Eagle Ranch Association
Regular Meeting
Design Review Board

Thursday, February 15, 2024
2:00 p.m. MDT

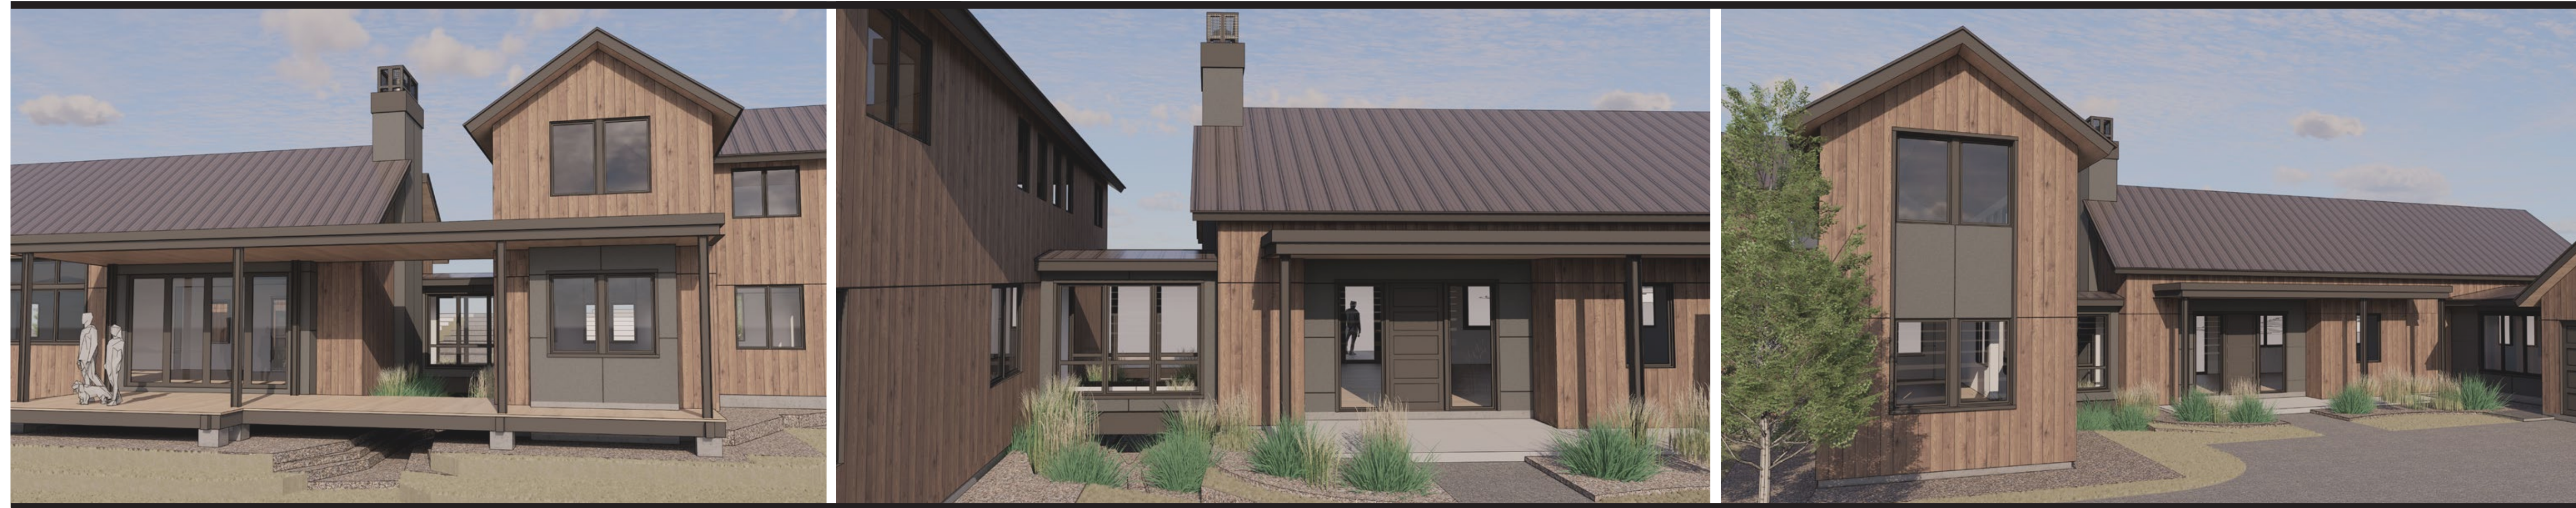
Staff recommends approval of the Preliminary Plan Review for the Ostmeyer Residence with the following conditions:

1. General Condition: Compliance with the Eagle Ranch Design Guidelines and process is not a substitute for compliance with Town of Eagle regulations, State regulations, or Federal regulations. Additional permits and approvals may be required by these agencies prior to commencing any work on the property. The property owner and its agents are responsible for ensuring compliance with all local, state, and federal regulations.
2. The applicant shall address the comments provided in this staff memorandum and any DRB comments prior to submittal for Final Plan Review.
